APPLICATION FOR PERMIT TO CONSTRUCT WITHIN A PUBLIC WAY

PROPOSED RECTIFIER AND GROUND BED INSTALLATION WILLOW STREET ACTON, MA.

INTERDEPARTMENTAL COMMUNICATION

Subject: National Grid, Cathodic Protection Work Request - Rectifier & Rectifier Pole
1.) Kinsley Road @ Kinsley Lane and
2.) Willow Street @ Duggan Road

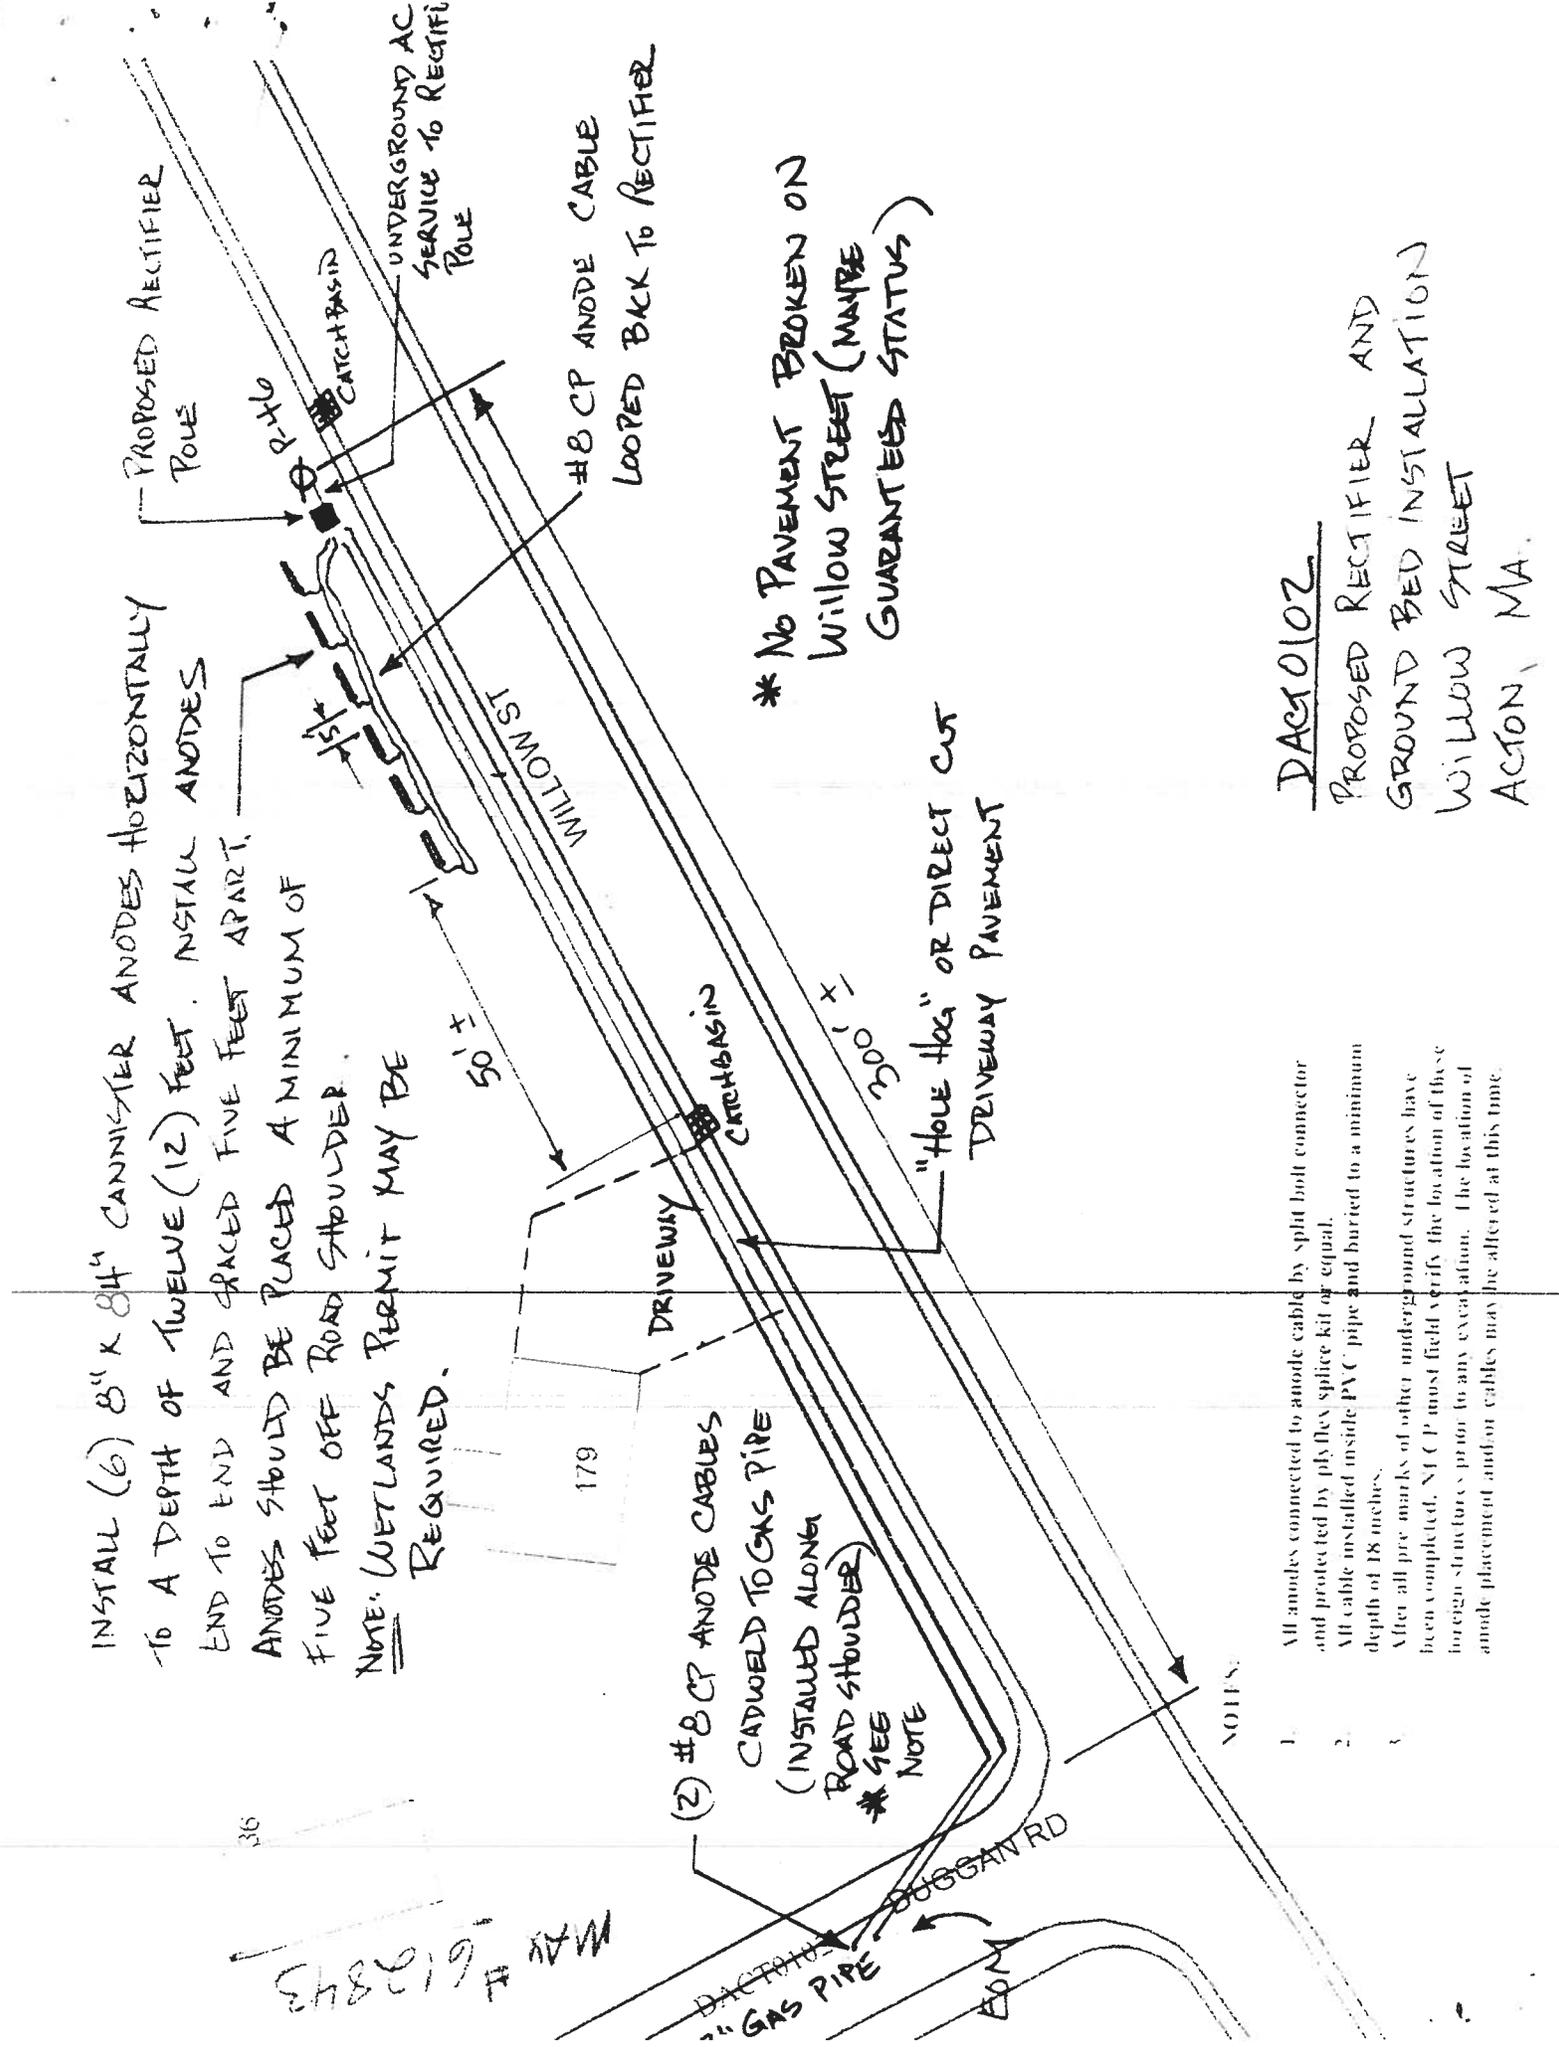
- The plans for Willow Street location also seem to indicate the edge of the road layouts for Willow Street & Duggan Road. The sketch appears to show the proposed utilities on private property. If so, National Grid will need to seek permission from the private landowners before they can enter upon the premises. The Town does not have the authority to grant permission to work on private property.
- National Grid will be trenching across the driveway for house #179 & possibly the bark mulch in front of the house in order to access the gas main on Duggan Road. National Grid should repave the driveway in compliance with the Town Specifications for Regulating Work within Public Ways, and replace the bark mulch with the same type of material.

Figure 3 - UP #9 on Kinsley Road opposite house #17 & #21

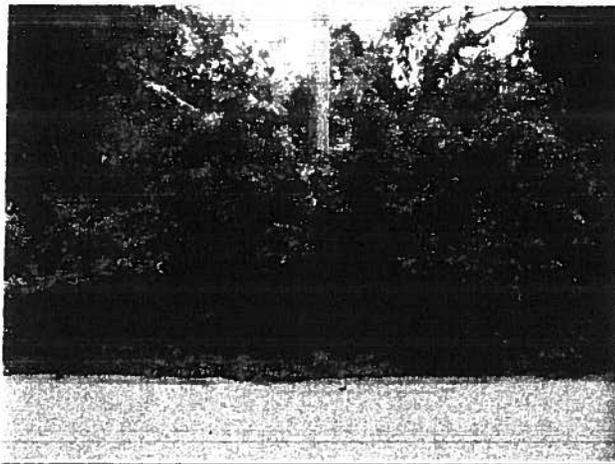
- The plans for Kinsley Lane indicate that the road layout is only 20 feet wide. The sketch from National Grid appears to indicate the edge of the road layouts for Kinsley Road and Kinsley Lane. As shown on the sketch, the proposed anodes will be located on private property owned by house #17. As stated above, if the work is located on private property, National Grid will need to seek permission from the private landowners before they can enter upon the premises. The Town does not have the authority to grant permission to work on private property.
